# CITY OF ALBUQUERQUE

RE: **Lot 10 Block 4 Unit 18 SAD 228**  
**Volcano Cliffs Subdivision**  
**6611 Cuervo Pl. NW**  
**Grading and Drainage Plan**  
**Engineers Stamp Date 12/13/2021 (D10D003J10)**  
**CO Certification Date 12/12/2022**

Based on the Certification received 12/14/2022, this site cannot be accepted for release of Certificate of Occupancy by Hydrology until the following comments are addressed.

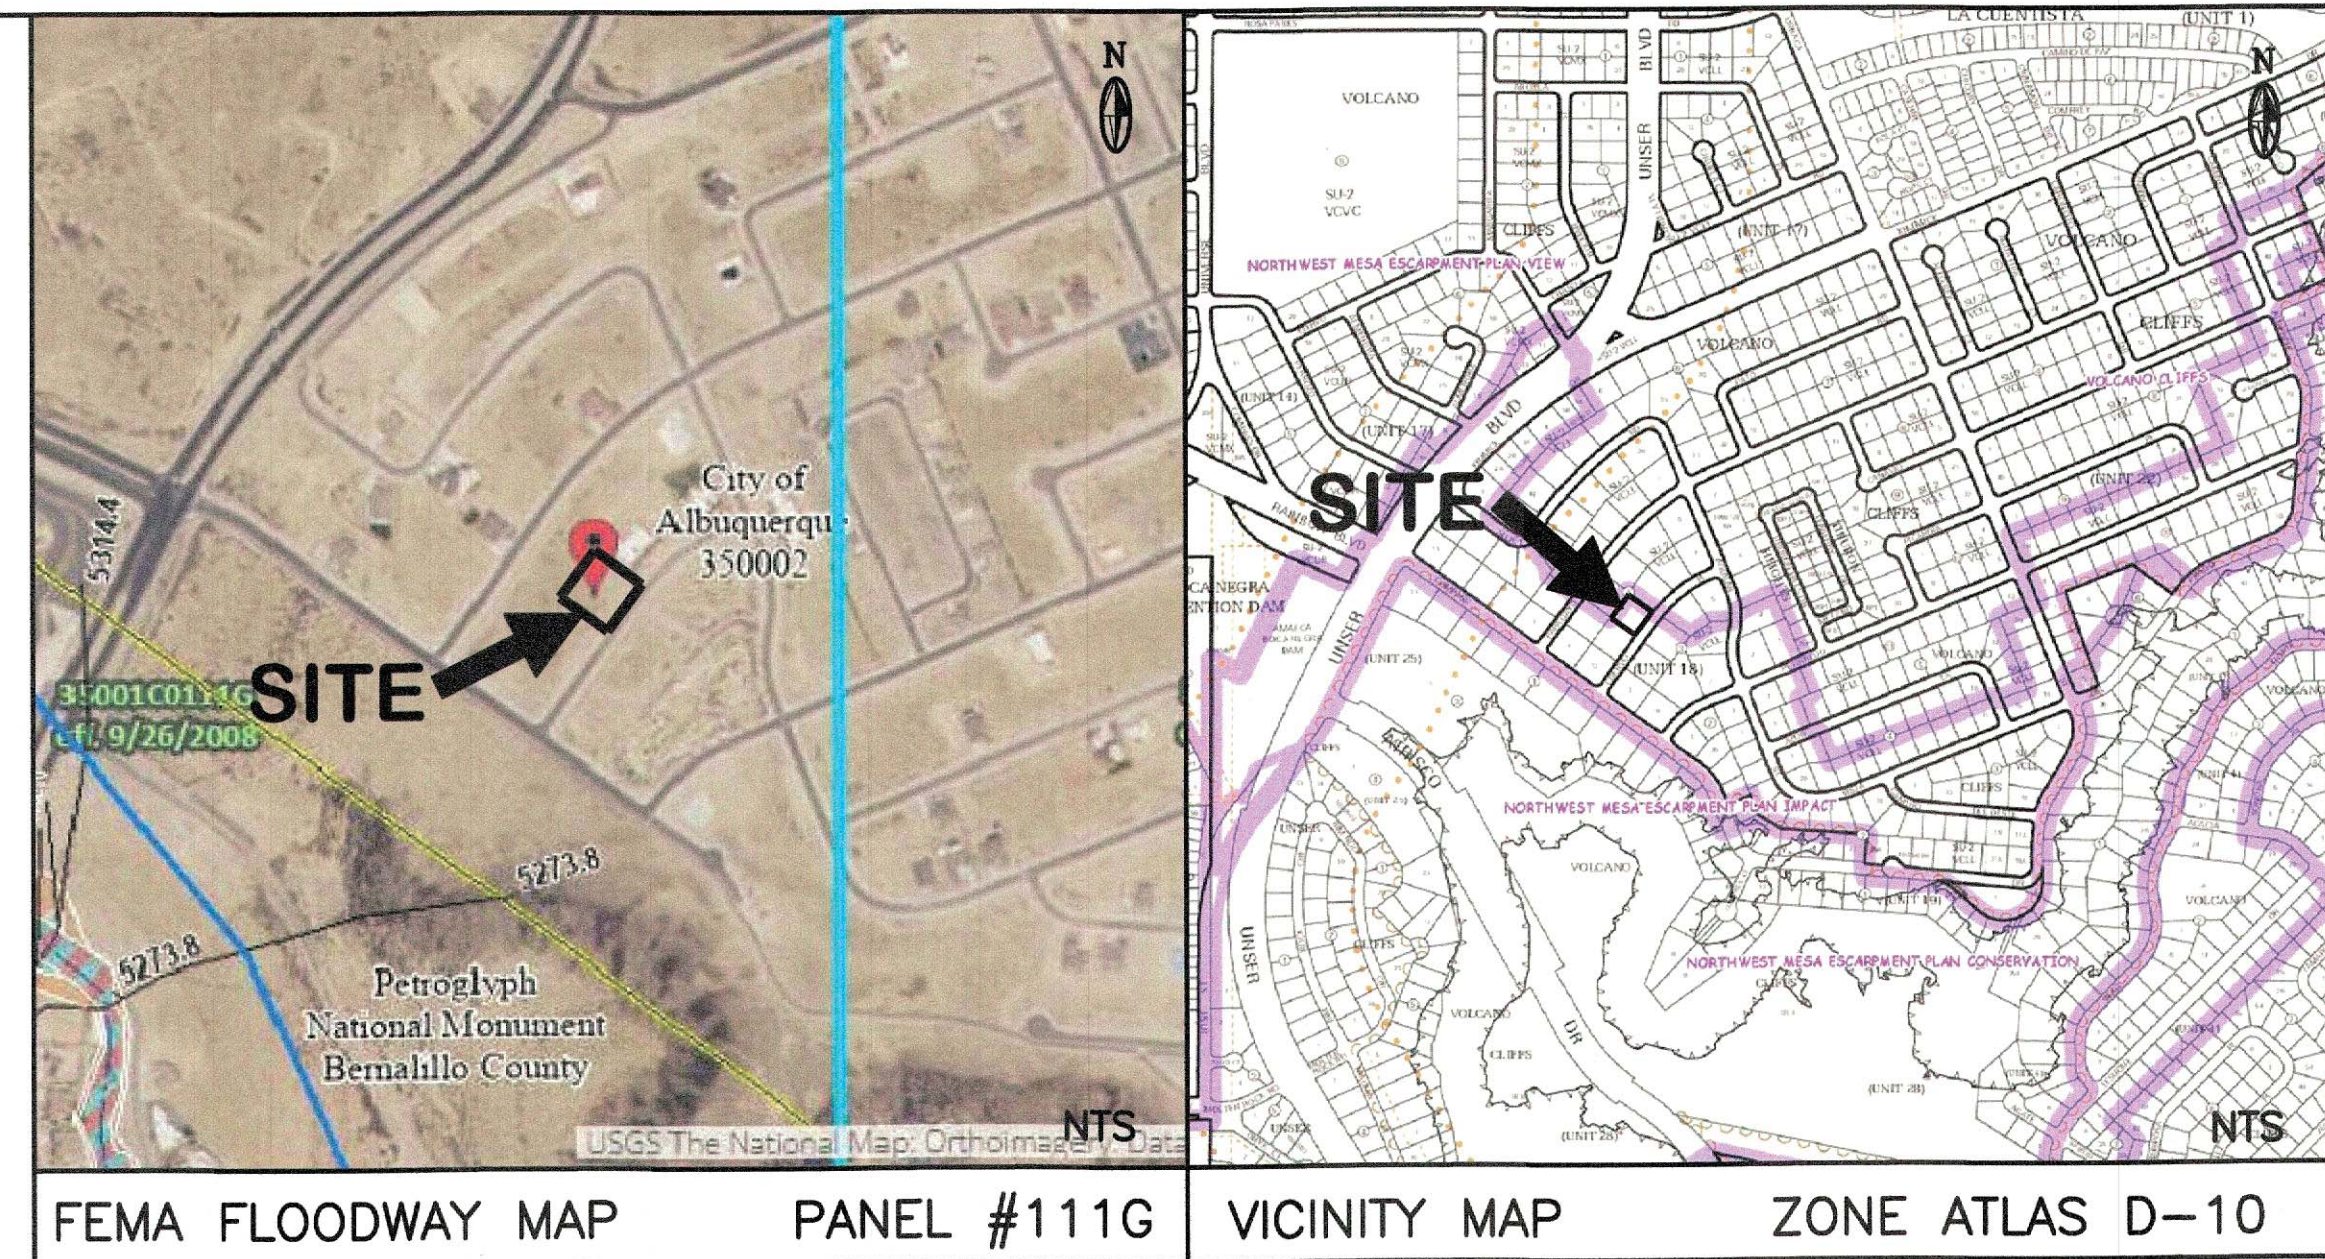
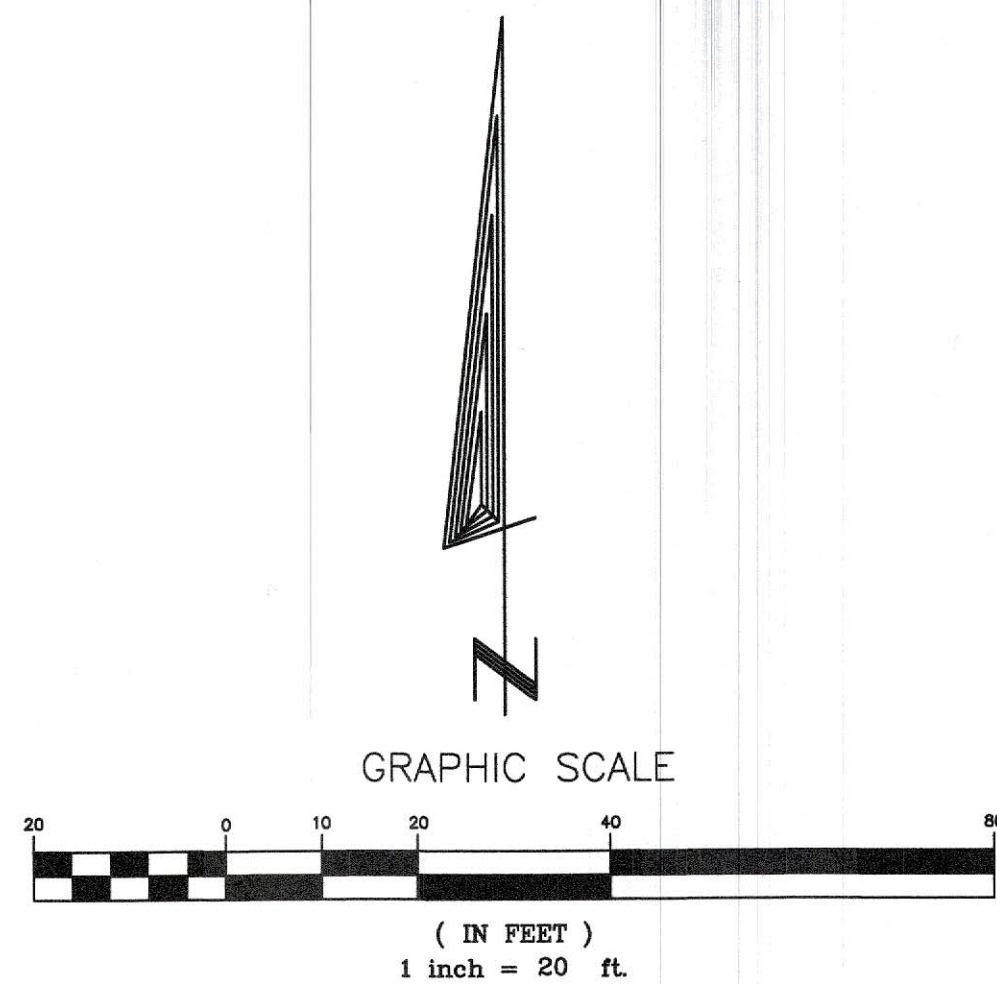
- Provide gravel in all ponds and swales.
- Provide a ponding area in the SW corner. Driveway blocks the flows heading to the NE corner.
- It is acceptable for flows to enter volcano cliffs property; however, there must be a sediment pond in place before these flows enter public land.
- Erosion protection is required at block fence.
